SUBJECT: Forwards responses to NRC questions 251.2, 251.3, 251.5, & 251.7 re fracture toughness. Responses will be incorporated into FSAR in future amend.

Subject: Palo Verde Nuclear Generating Station  
(PVNGS) Units 1, 2 and 3  
Docket Nos. STN-50-528/529/530  
File: 81-056-026; G.1.10

References: A) Letter from R. L. Tedesco, NRC, to E. E. Van Brunt, Jr.,  
dated August 13, 1981; Subject: Request for Addi-  
tional Information and Draft SER Inputs (Materials  
Engineering Branch) (MTEB)  
B) Letter from EEVB Jr. to R. L. Tedesco,  
dated August 28, 1981, ANPP-18793

ARIZONA NUCLEAR POWER PROJECT  
PALO VERDE UNIT NO. 1  
R.V. BELTLINE REGION

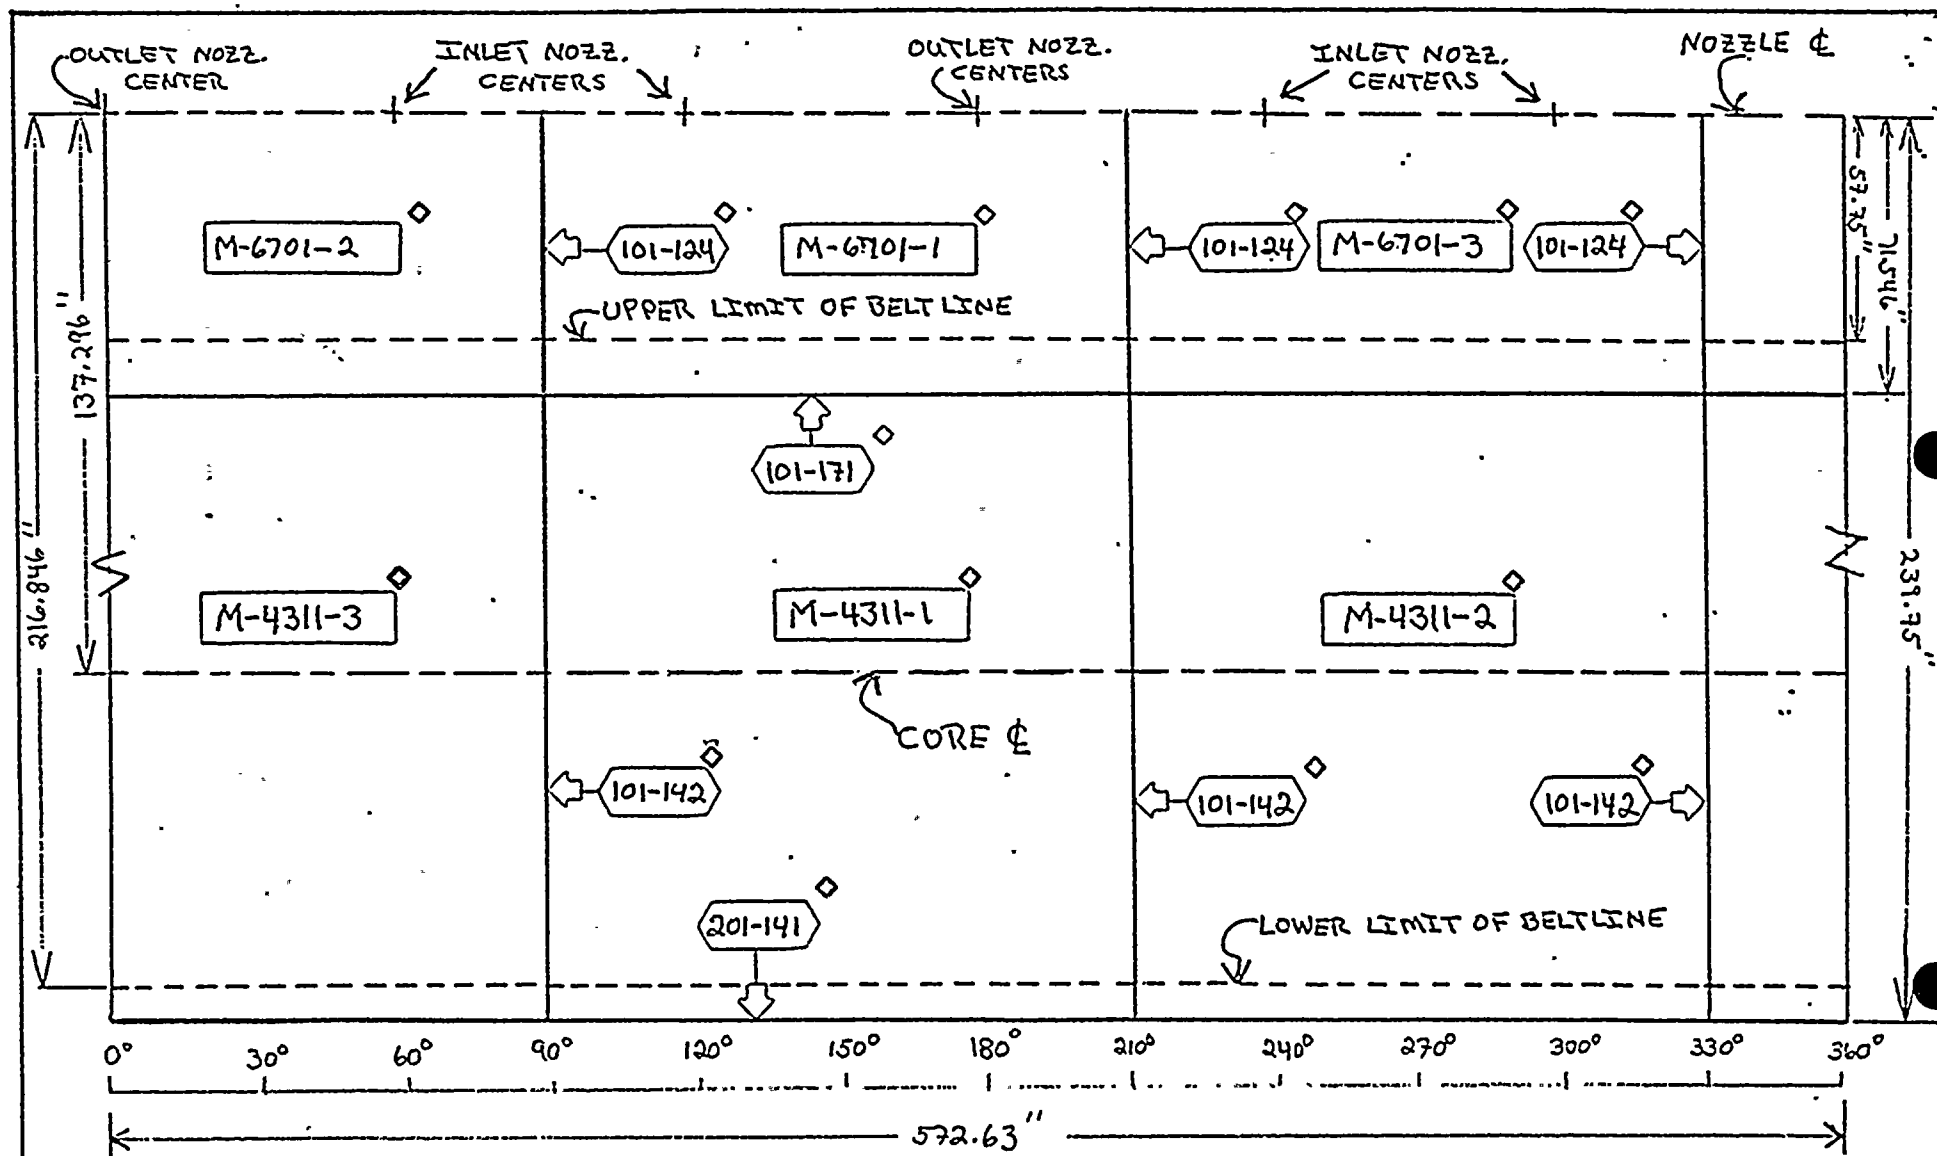
Question 251.2 (a) "To demonstrate compliance with the fracture toughness requirements of paragraph IV.A.1 of Appendix G, 10 CFR Part 50:

Provide a schematic of the reactor vessel showing all welds, plates and/or forgings in the beltline. Welds should be identified by shop control number, weld procedure qualification number, the heat of filler metal, and type and batch of flux. Provide the chemical composition for these welds (particularly Cu, P, and S content). Identify material specification, type and grade of all base metal."

- (a) A schematic of the reactor vessel beltline region showing weldseam numbers and plate code numbers is shown in figure 1 of this document.
- (b) Weld procedure qualification numbers and associated fracture toughness data from weld procedure qualification tests for the reactor vessel will be provided in the ~~WVRS~~ FSAR (Table 5.2.3-4) by 10/1/81.
- (c) Weld metal used in the fabrication of the R.V. beltline and its fracture toughness properties from weld metal certification tests will be provided in the ~~WVRS~~ FSAR (Tables 5.2.3-3A) by 10/1/81.
- (d) For chemical composition of welds in the R.V. beltline, see Table 5.3.1-2 of ~~the~~ FSAR.
- (e) For chemical composition of plates in the beltline, see Table 5.3.1-1 of ~~the~~ FSAR.
